# ORIGINATION FORM

Index Number: 521-600  
Sheet Number (s): 1 & 2  
Index Title: MSE Wall Coping (Precast or C-I-P)

## Summary of the changes:

SECTION A-A C-I-P COPING

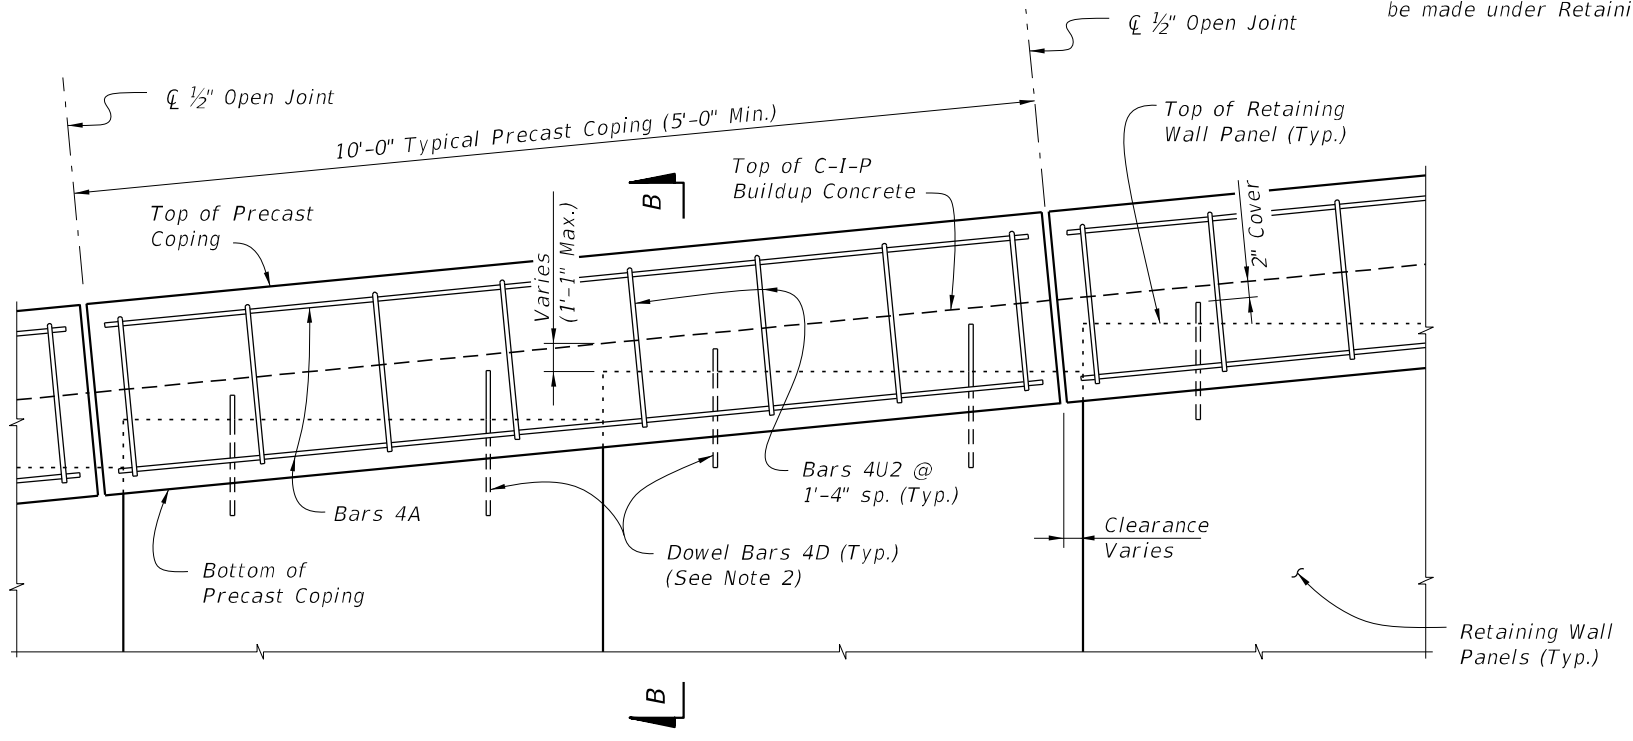
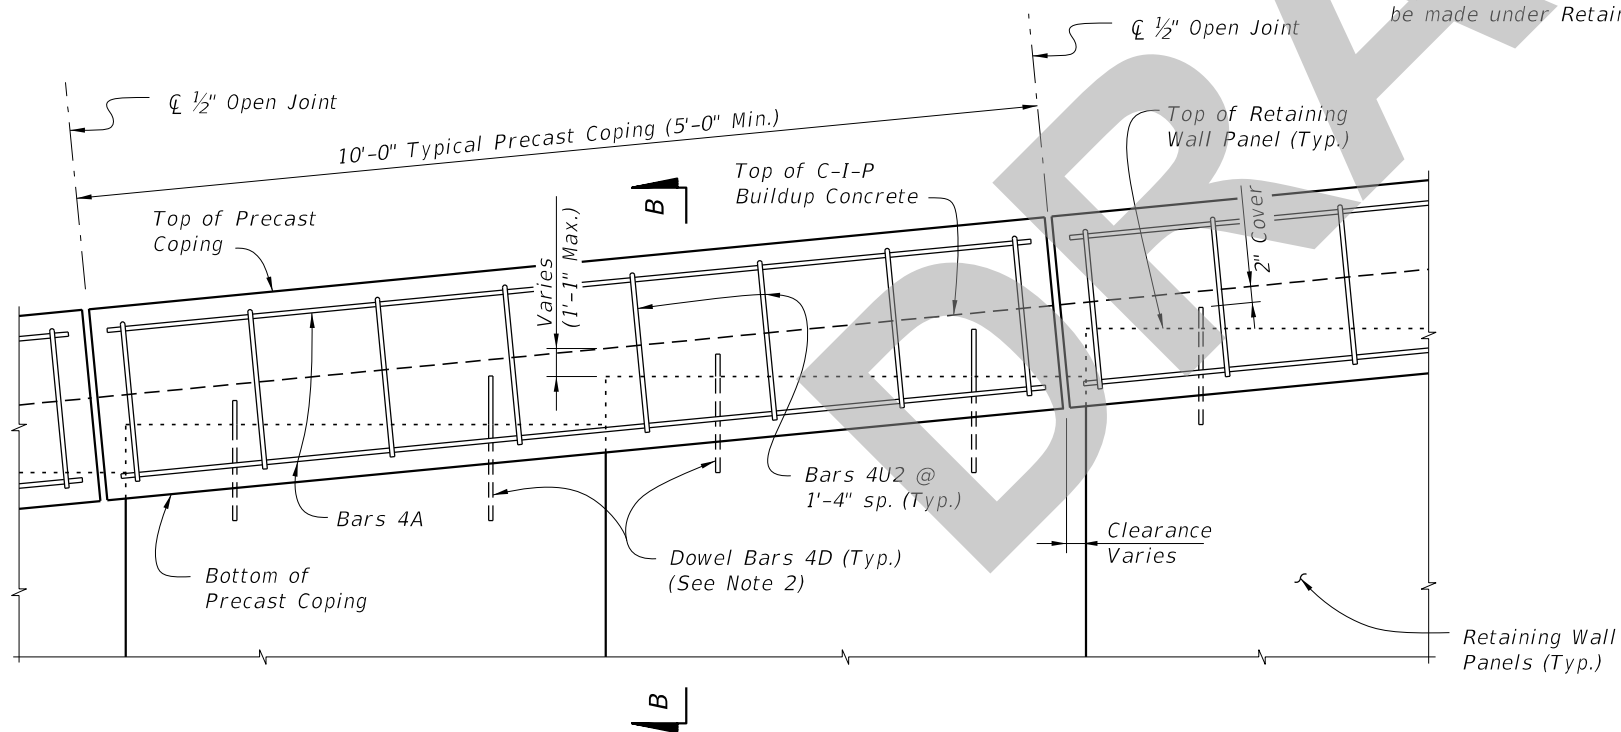
Added bond breakers between wall and C-I-P copings

To prevent issues with shrinkage cracking between the two surfaces (mostly with block wall)
